# **WORCESTER COUNTY PLANNING COMMISSION AGENDA**

**PURPOSE:** Site Plan Revision Review

**PROJECT:** Seaside Village Major RPC Step II and Step III Phase 2A site plan revisions.

Re: Seaside Village RPC Revisions  
Phase 2A Steps II and III  
GMB No.: R200090.00 Task 002

#### DUMPSTER ENCLOSURE

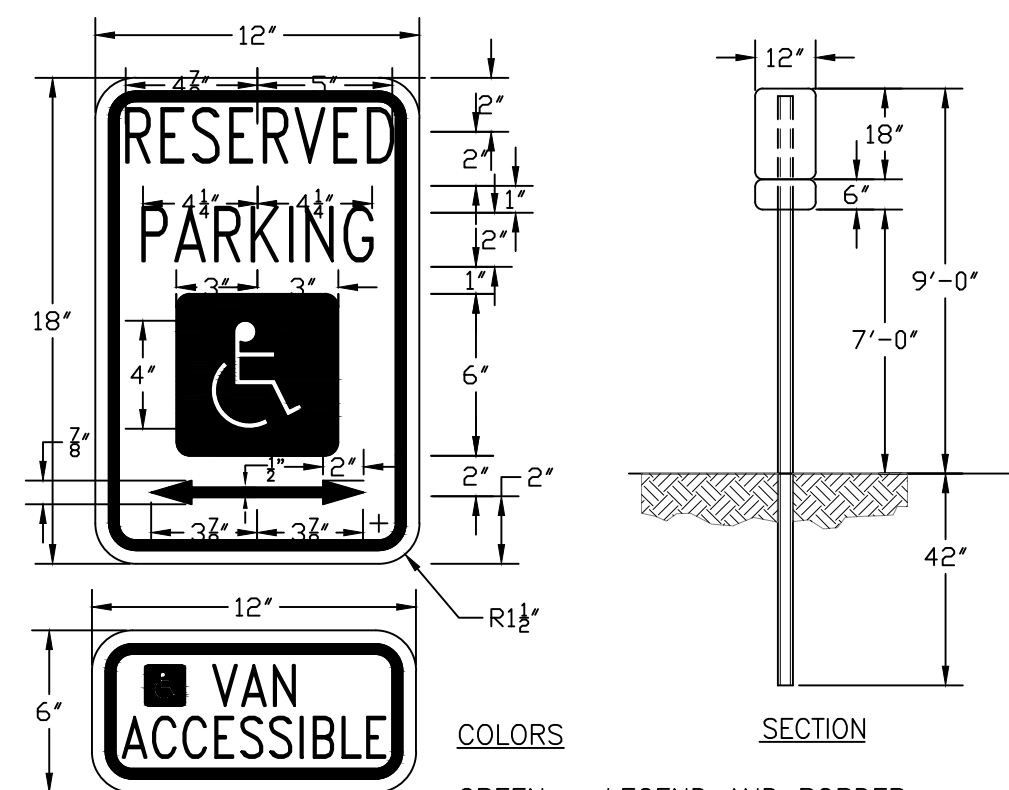
5. Please provide a detail for the dumpster enclosure and for ADA handicapped signage.

***Details for dumpster enclosure and ADA handicapped signage have been added to Sheet C2.3.***

SCALE: 1" = 20'  
DESIGN BY: KK  
DRAWN BY: KK  
CHECKED BY: DJR  
GNMB FILE: 200090  
DATE: OCT 2022  
SHEET NO.  
**C2.3**

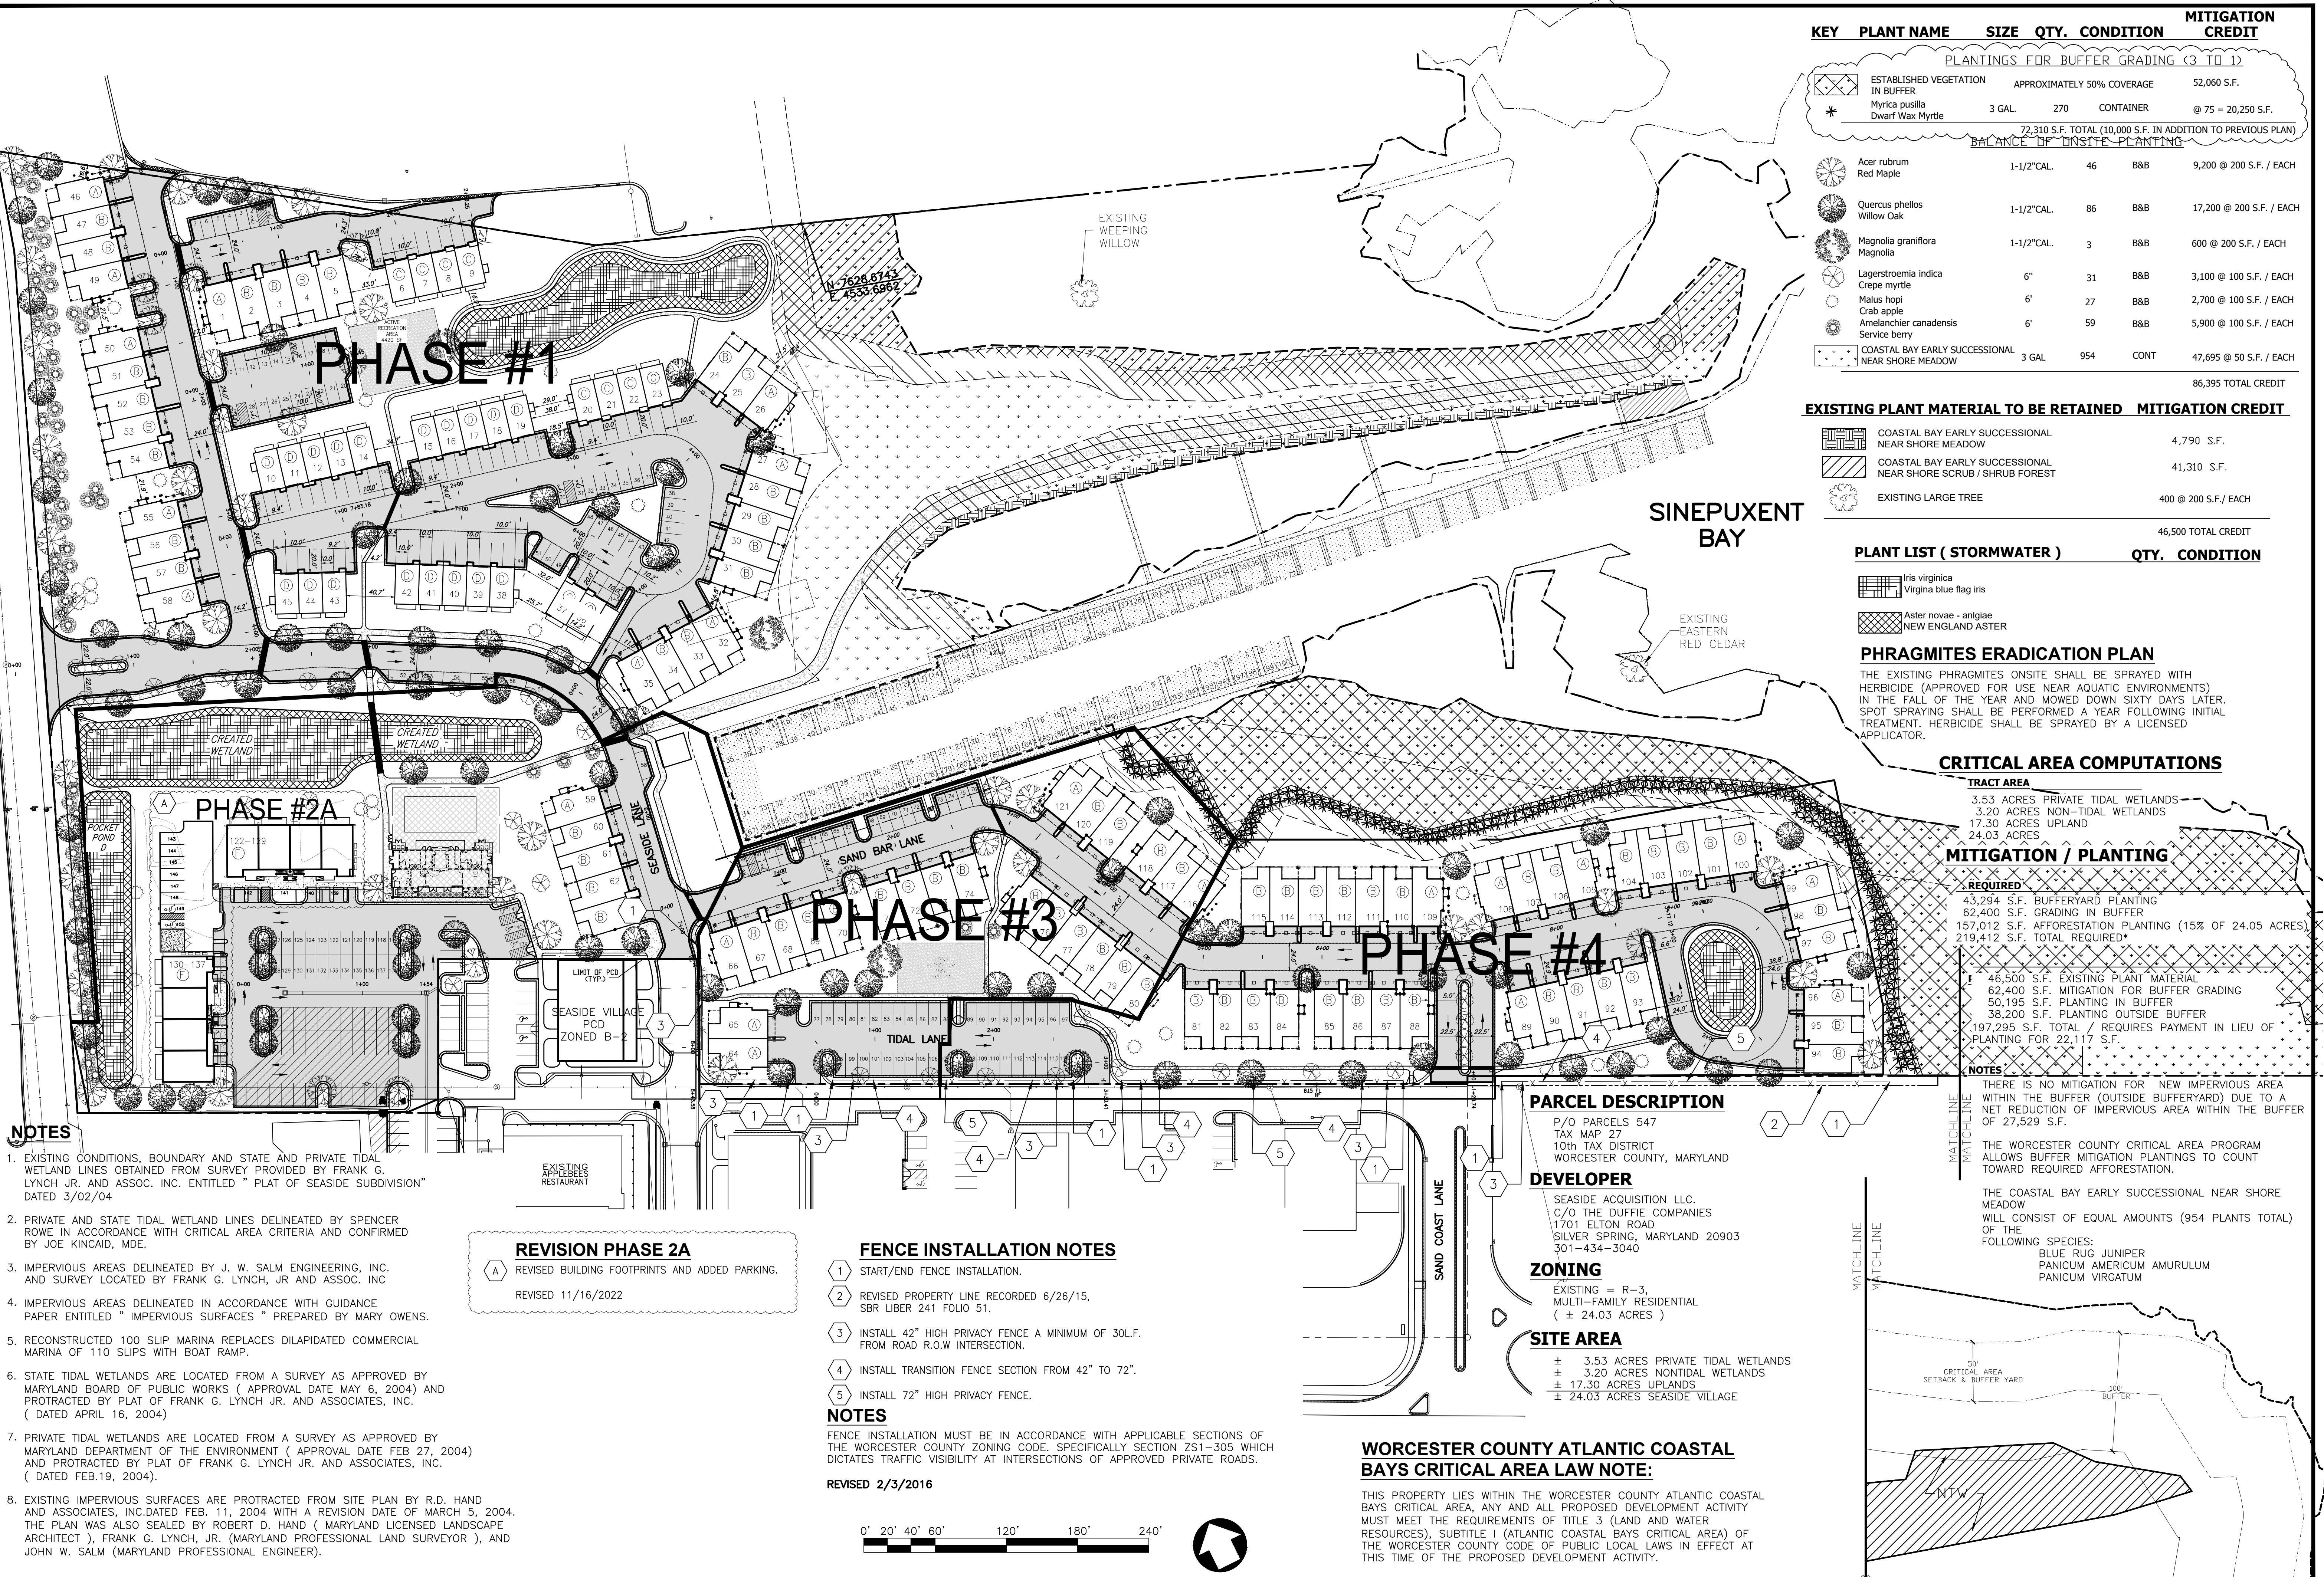
3. Sheet C2.2 is difficult to read with the combined site plan and stormwater plan. Please provide these items on separate sheets prior to the Planning Commission meeting.

6. Please show the dimensions of the ADA handicapped spaces on the site plan.

***Sheet C2.3 Site Plan has been added for clarification.***

***Dimensions of the ADA handicapped spaces have been added to Sheet C2.3.***
